CITY OF FISHERS AGENDA

a. **Fishers Marketplace Text Amendment**
   Parcel: 15-11-30-00-42-002.000
   Case: PUD-24-13
   Request: Request to approve the site plan and architecture for a new gas station with a convenience store and car wash within the Fishers Marketplace PUD at 13498 Bent Grass Lane.
   Petitioner: Joe Calderon (jcalderon@btlaw.com)
   Planner: Christy Cashin (cashinc@fishers.in.us)

Planned Unit Development (PUD) Committee
Staff Report

TDEPARTMENT CONTACT: Christy Cashin (cashinc@fishers.in.us)	**CASE NUMBER:** PUD-24-13
PETITIONER: Joe Calderon (jcalderon@btlaw.com)	**PROPERTY ADDRESS/LOCATION:** 13498 Bent Grass Lane

Concept plan

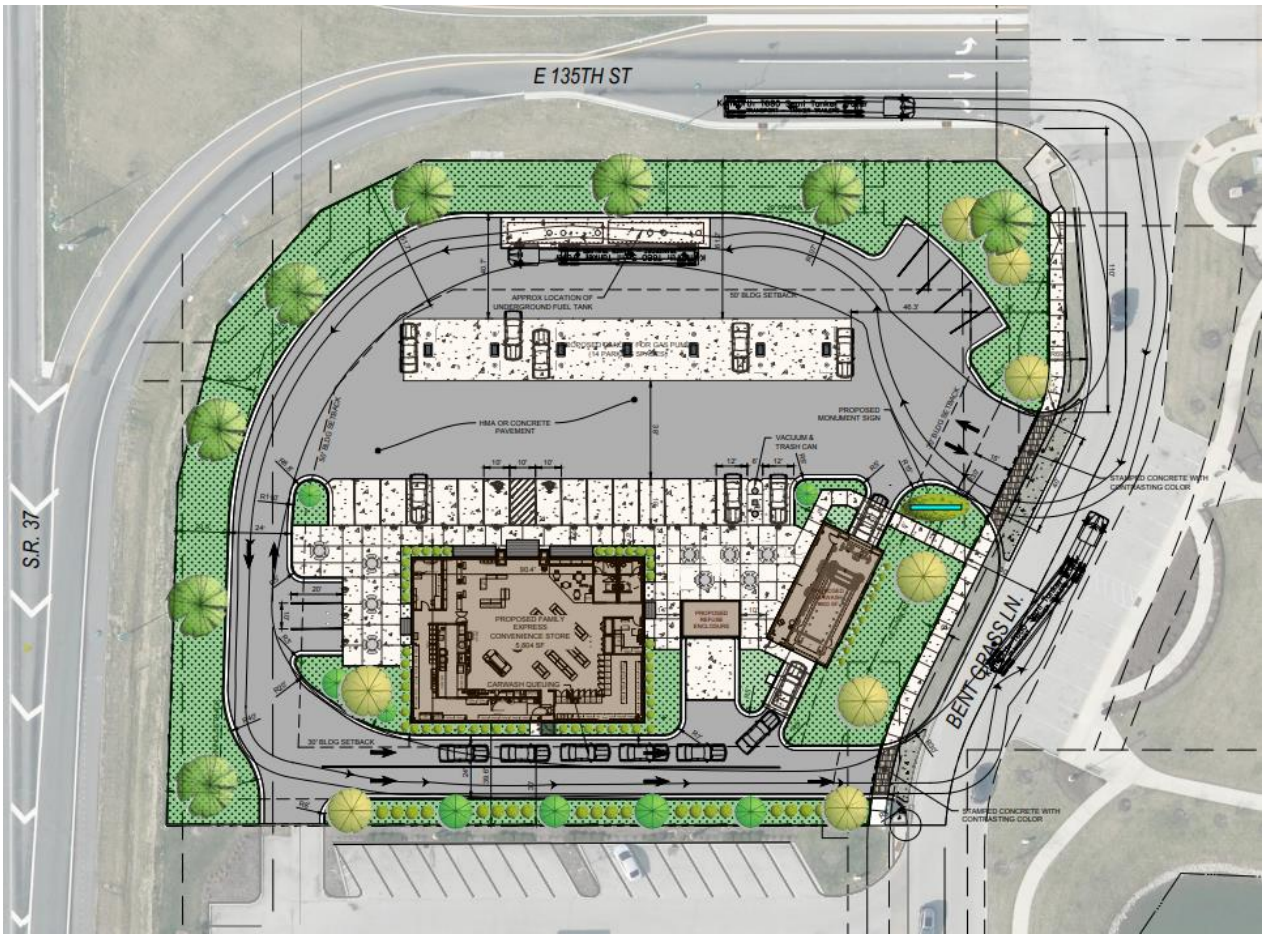
Petitioner is requesting to build a gas station with seven pumps (14 fuel fill up locations) on a 1.93 acre lot. The request is to also build a 5800 SF convenience store and a 1300 SF automated car wash. The project will have a plaza/patio area with seating between the store and the car wash buildings and on the west side to the store. Sidewalk connections have been made along Bent Grass Lane for pedestrian connectivity to the site.

Staff recommends the PUD Committee approve the site plan and elevations as proposed.
